Refer to: HSA-10/SS-122

Thank you for your letter of December 15, 2003, requesting Federal Highway Administration (FHWA) advice on testing your company's Shur-Tite® socket system as a breakaway mechanism for rural mailbox supports for use on the National Highway System (NHS) under the provisions of National Cooperative Highway Research Program (NCHRP) Report 350 "Recommended Procedures for the Safety Performance Evaluation of Highway Features." You provided video documentation of bogie vehicle testing and static pull testing, and asked if a pendulum test would be adequate to prove the breakaway performance of the mailbox support.

SHUR-TITE® DESIGN DRAWINGS

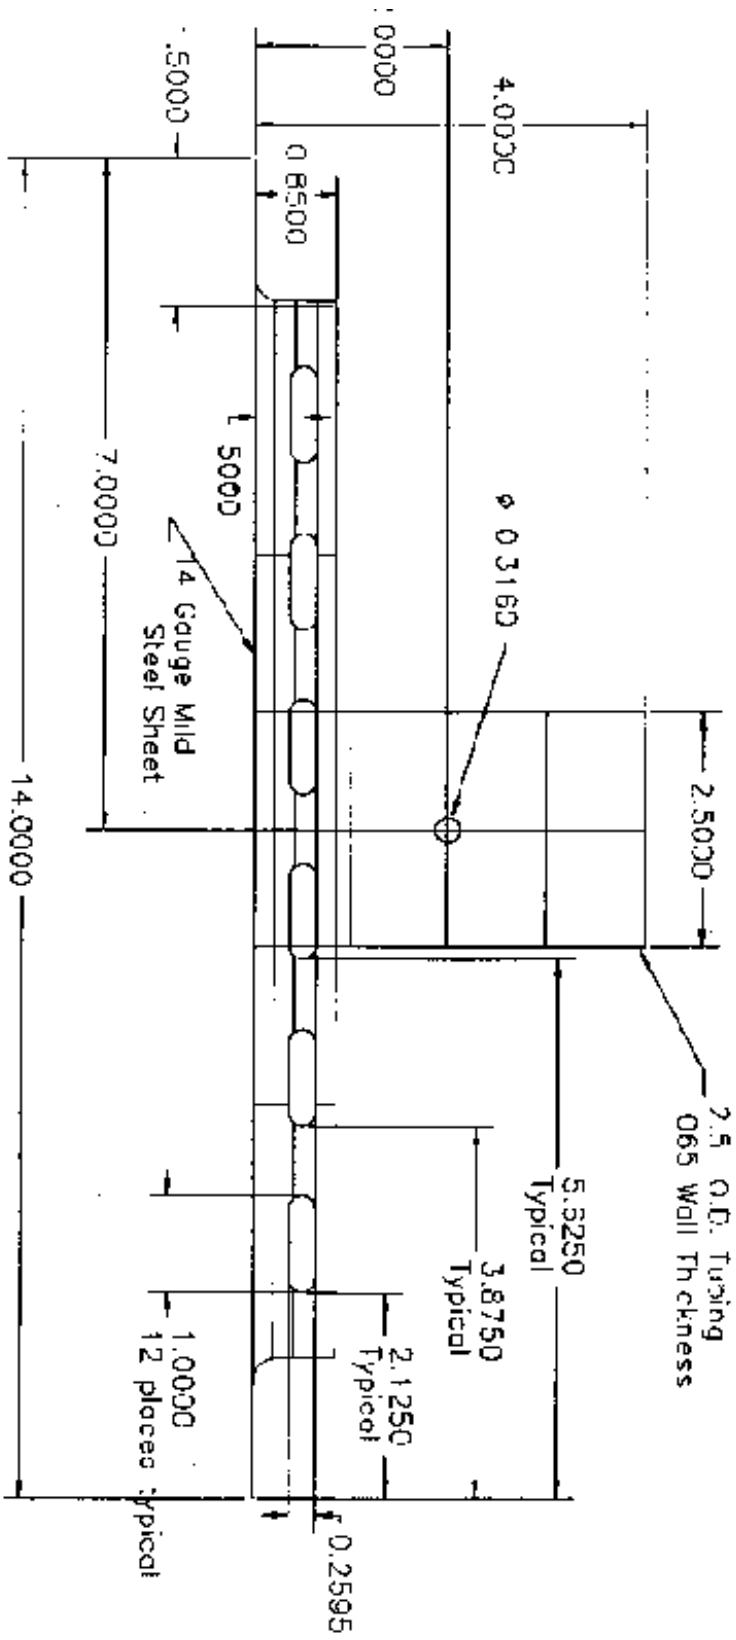
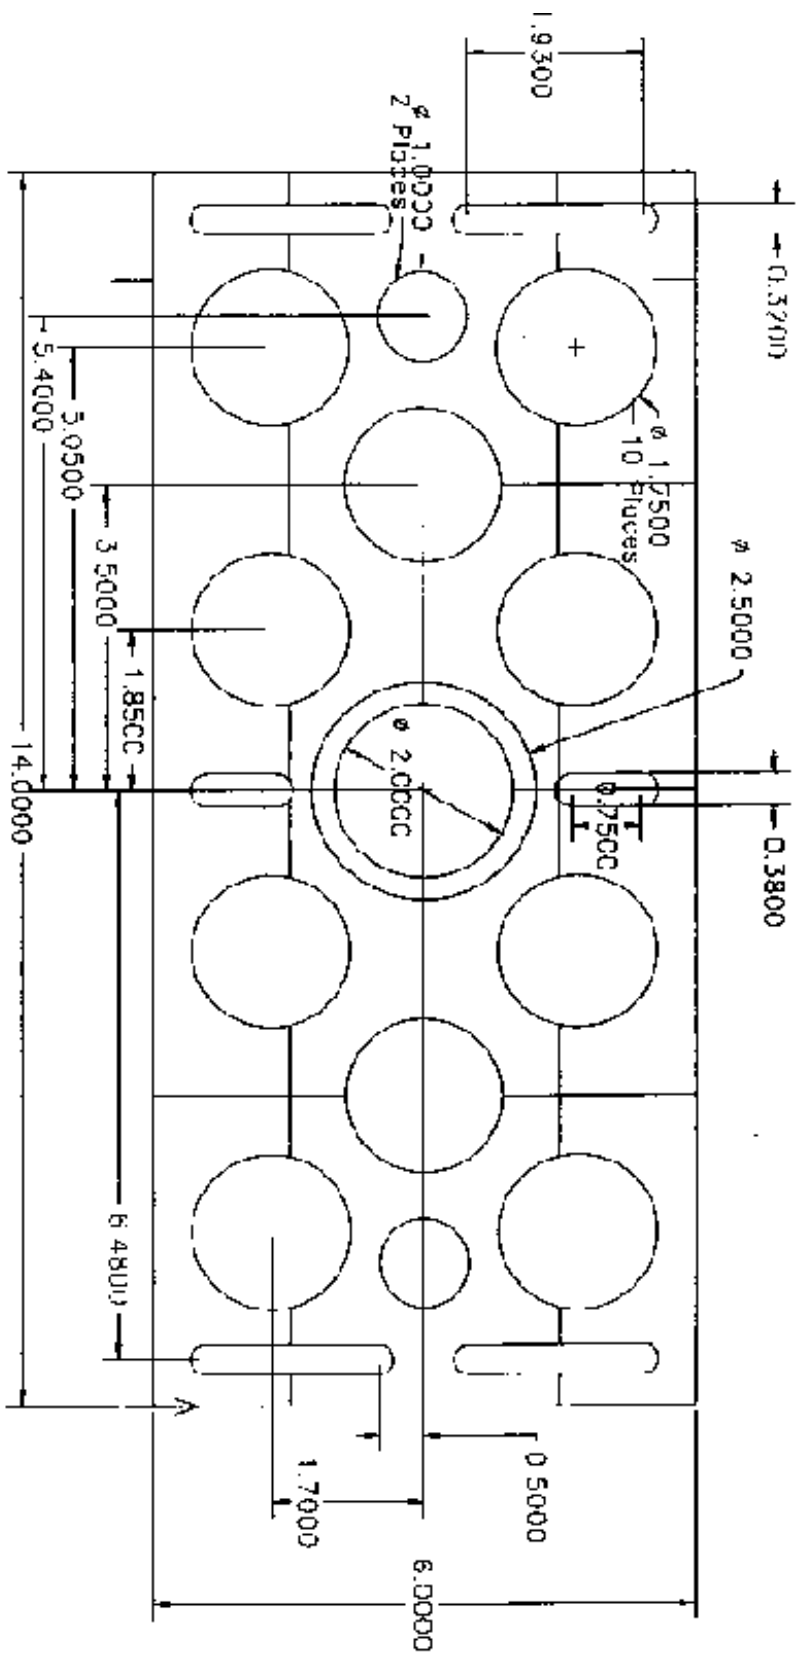
The Shur-Tite® Mailbox Bracket is shown in the enclosed drawing for reference. It is formed from a sheet to 0.074 inch 14 gage A36 steel. A pair of downwardly extending flanges are formed on the long edges of the plate. The flanges have holes to facilitate attachment to the mailbox, and additional holes reduce the weight of the bracket. A cylindrical sleeve of 1020 steel with a 2.5 inch OD by 0.065 inch wall is wire welded to the plate forming a socket to receive the post. A 5/16" bolt secures the bracket to the post through holes on both sides of the sleeve and the support post.

We agree that a single pendulum test would be adequate to demonstrate the satisfactory breakaway performance of the Shur-Tite® Socket System in a mailbox support. However, we have also compared the Shur-Tite® mailbox installation to other conventional mailbox supports such as the 4x4 wood post. We consider a Type A rural mailbox attached to a 4x4 post, a very common and inexpensive system nationwide, to be minimally acceptable from a crashworthy standpoint. We believe that you have already demonstrated superior performance of the Shur-Tite® system to the 4x4 wood post and have decided to find it acceptable for use with a mailbox no heavier than that used in the bogie test.

The results of testing met FHWA requirements and, therefore, the devices described above and shown in the enclosed drawings for reference are acceptable for use as Test Level 3 devices on NHS under the range of conditions tested, when proposed by a State. Should you wish to use the Shur-Tite® system with multiple mailboxes, or with heavier, more secure mailboxes, then full-scale high-speed crash testing would be required.
